Re: HHSC 26-0057 RFP HBMC GENERATOR REPLACEMENT PROJECT-Solicitation Addendum No. 01 Scope, Responsibilities Clarifications with Q&A, Drawings/Specifications, and Revised Procurement Table.

This correspondence serves as Solicitation Addendum No. 01 to the subject Request for Proposals ("RFP").

Part Number: **A054F847** Part Revision: **G**
 Part Name: **OUTLINE,GENSET**
 Drawing Category: **Detail State: Released** Sheet 4 of 6

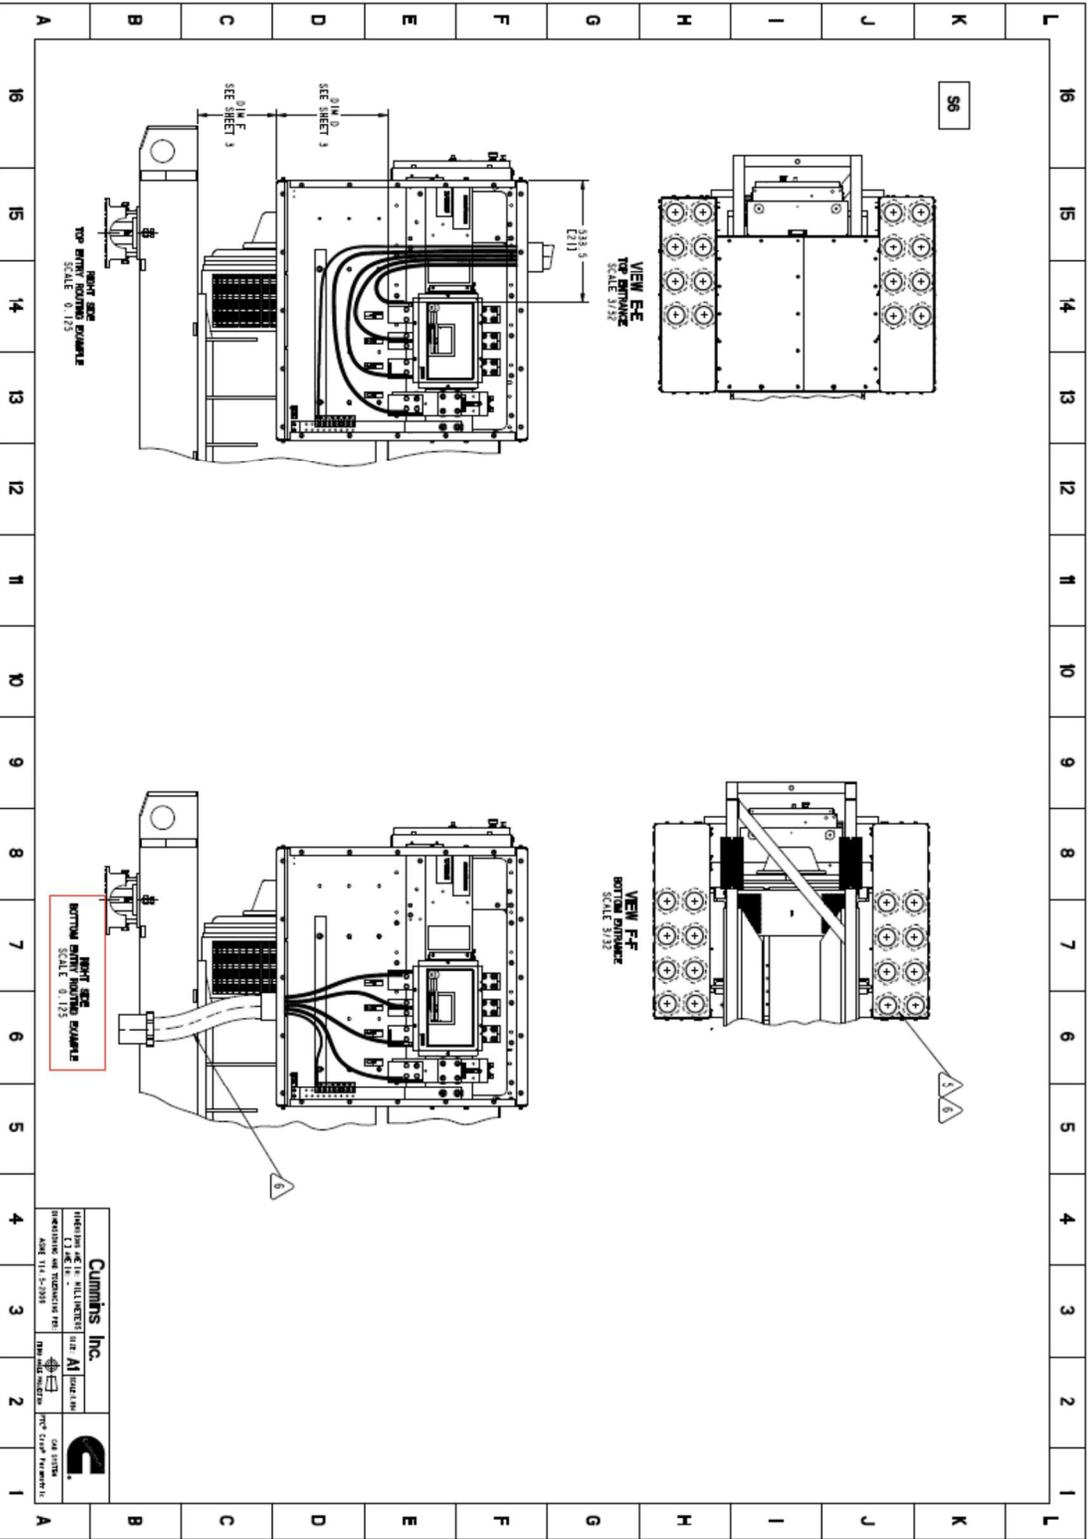
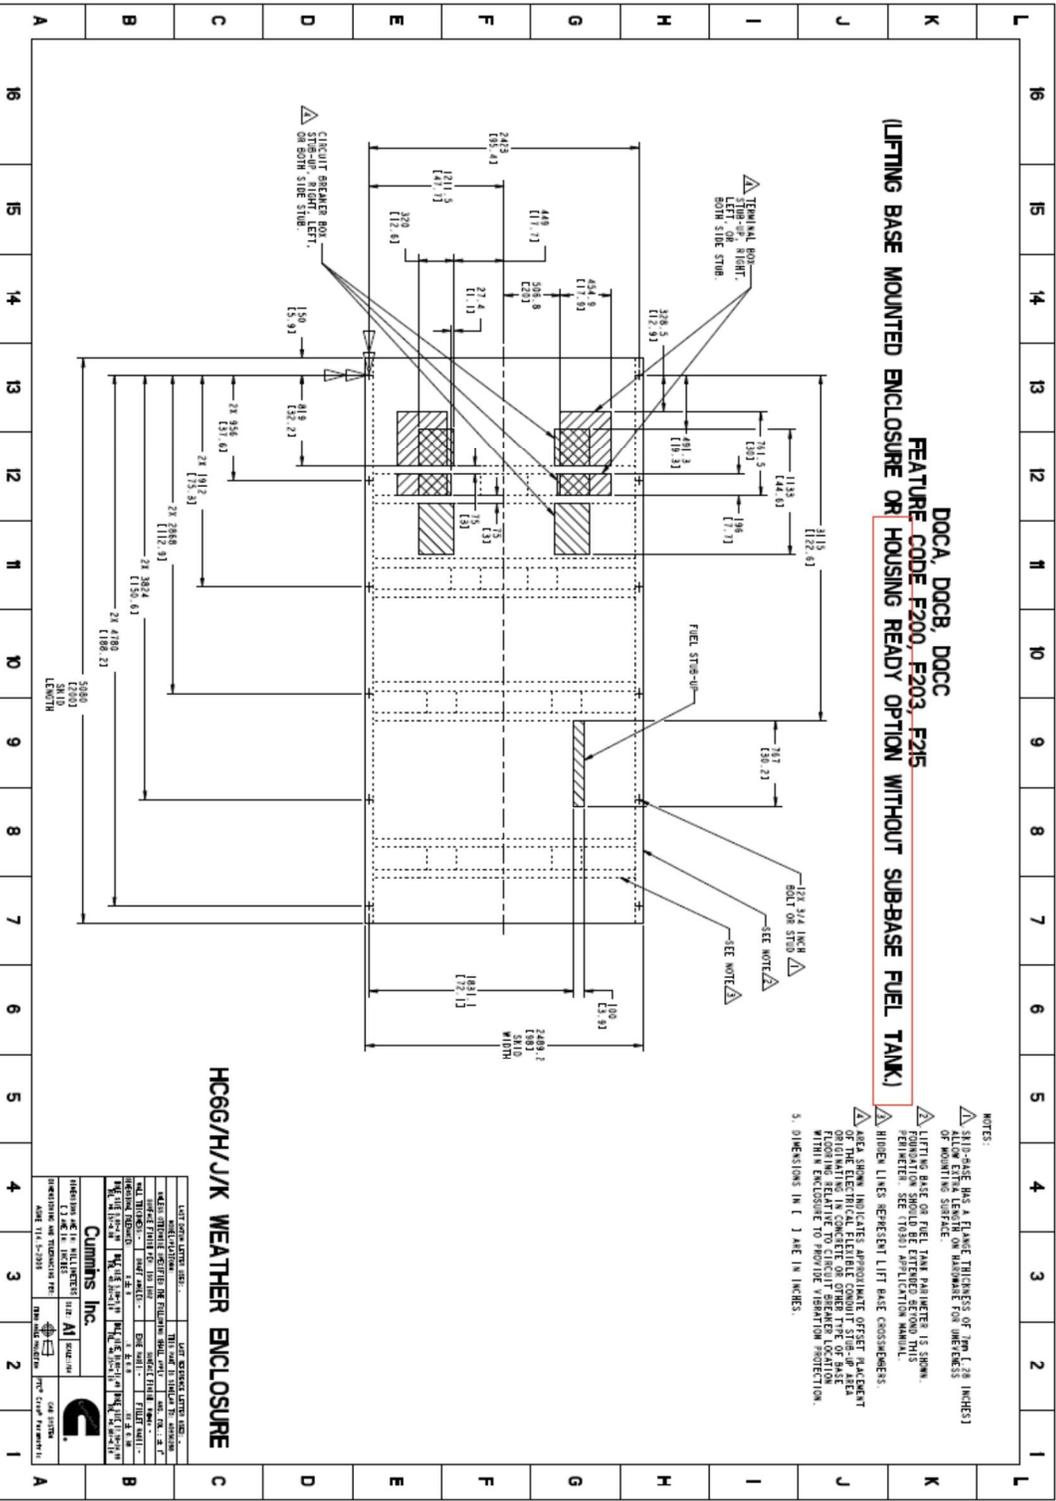
- A19. HBMC is collaborating with Majestic Engineer to provide advisory service, consultation and drawings for the project.
- Q20. Is the new generator enclosure required to be Stainless Steel? If so will 304 stainless be acceptable of 316 stainless steel if not available? Or will a standard aluminum enclosure be acceptable?**

- A20. This is unhoused generator and will be installed in the generator room using the existing pad. Concrete pad will be reused. Extension of the pad will be per the attached drawings. Extend the length and width of the existing pad by 3' to account for the proper clearance. The existing dimensions of the concrete pad measures in 6'-1' width X 14'-6" L. In contrast, the specifications for the new generator pad indicate a size of 8'- 1/8"W X 16'-8"L.
